6780B County Permit Review Worksheet

PERMIT APPLICATION FOR A RESIDENTIAL SITE
IMPROVEMENT PERMIT / CONSTRUCTION AUTHORIZATION
FOR ON-SITE WASTEWATER SYSTEM
NEW WELL INSTALLATION OR REPAIR OF EXISTING WELL
MECKLENBURG COUNTY GROUNDWATER & WASTEWATER SERVICES

IMPROVEMENT PERMIT for a RESIDENTIAL ON-SITE WASTEWATER TREATMENT & DISPOSAL SYSTEM

RE: Request for an Improvement Permit for Lot 42 at The Retreat at Latta Plantation off of Sample Road.
MCHD File #6780B

Scale: 1 inch equals 50 feet	S&ME	Faison-Sample Road, LLC	FIGURE
Drawn by: JBP		Lot 42	1
Reviewed by: Jeremy P. Michelone, RS		Mecklenburg County, NC	
Date: March, 2007	ENVIRONMENTAL SERVICES · ENGINEERING · TESTING	S&ME Project #1588-05-091

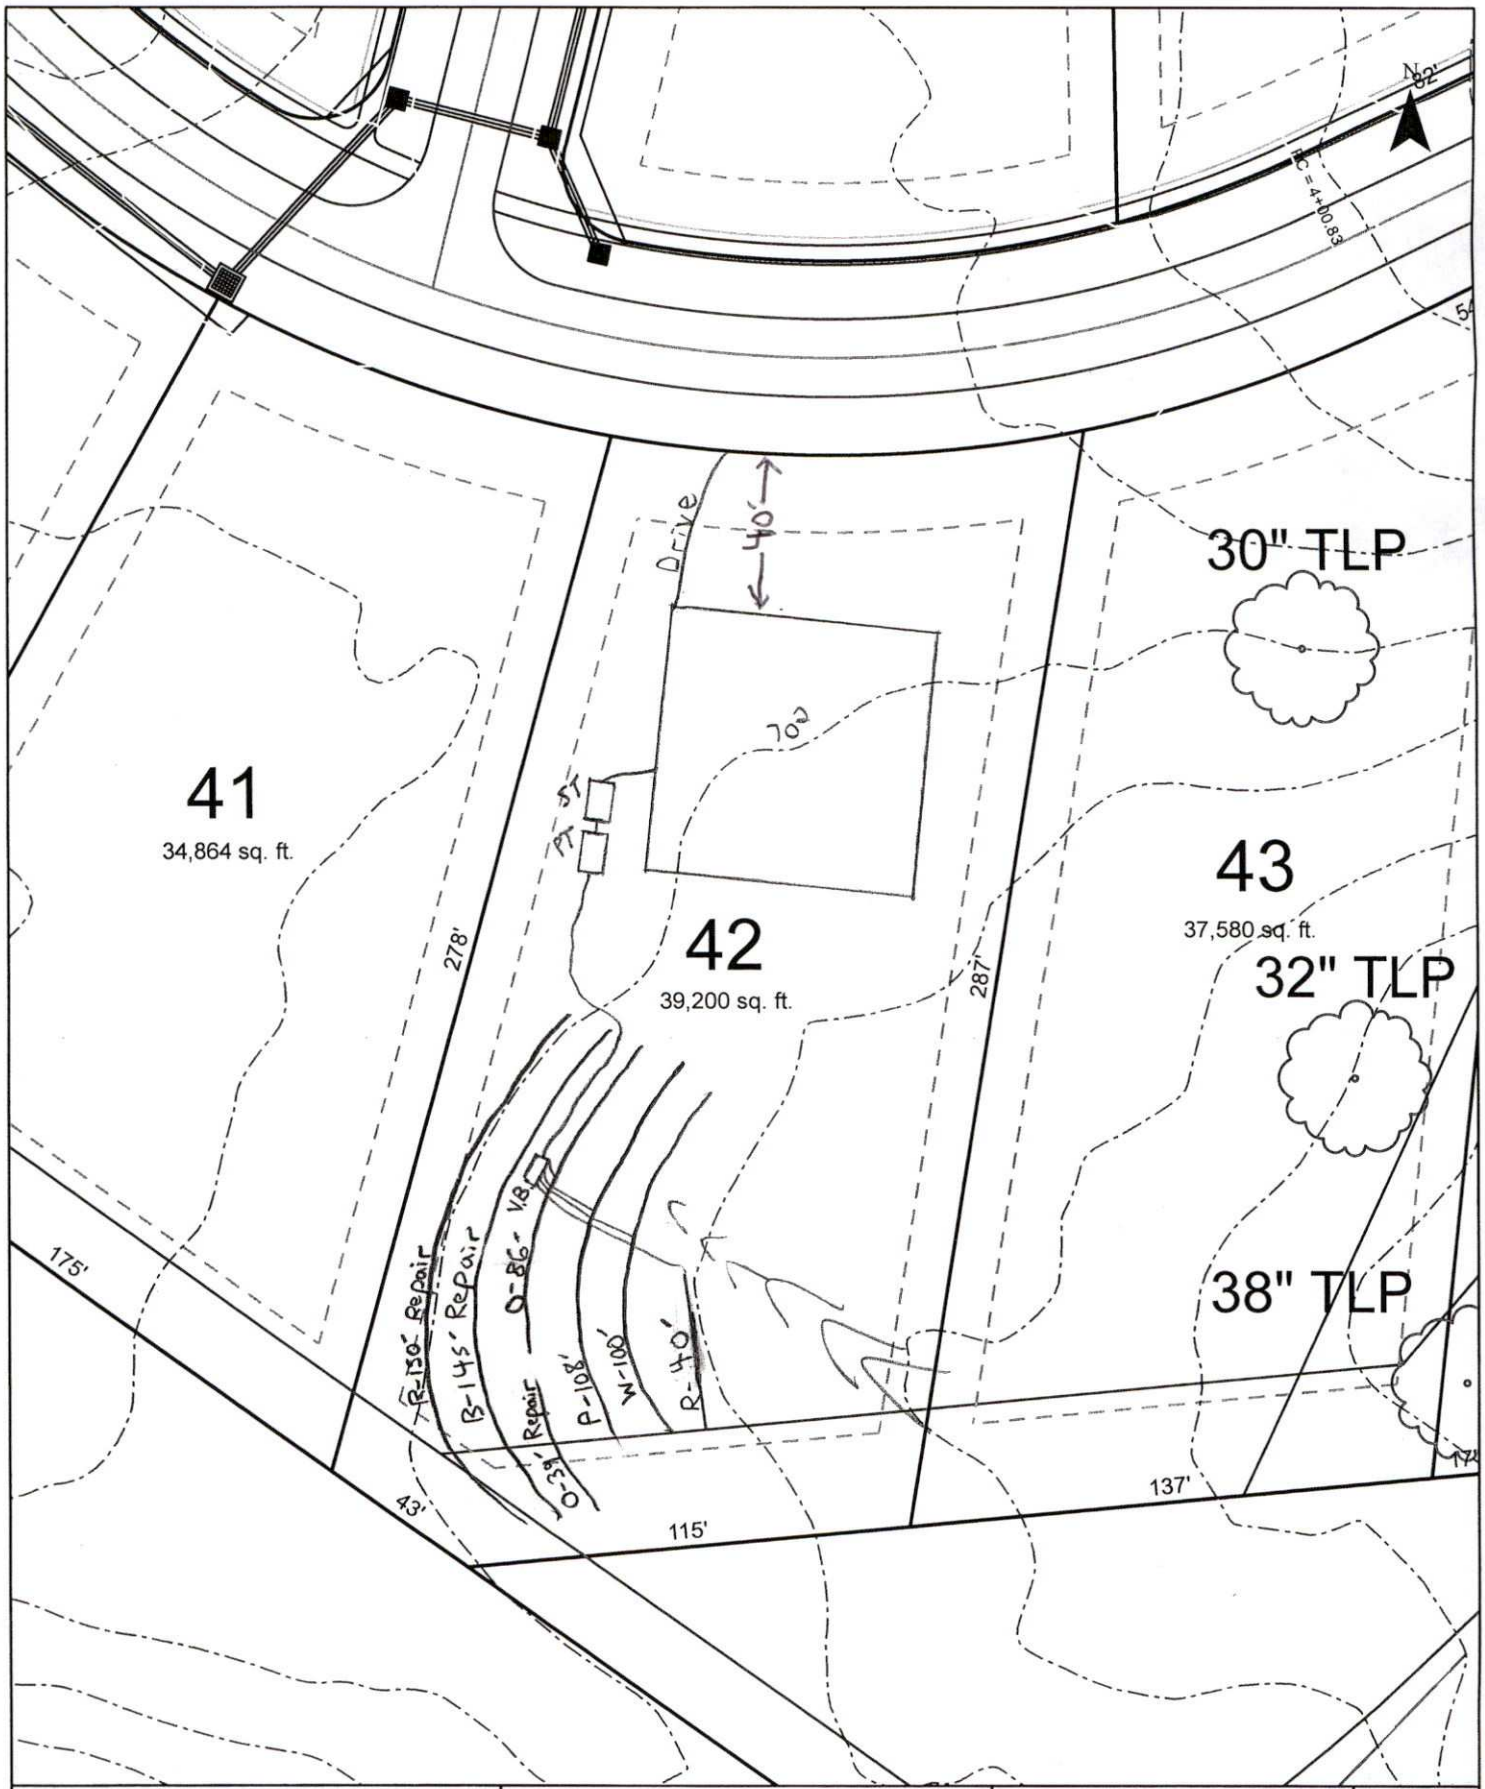
GWS Septic System Design Review

Approved	Disapproved
GWS File #: 6780B		
Design Review: TCT 4-9-07	☒	☐
Field Review: 4/5/07	☒	☐
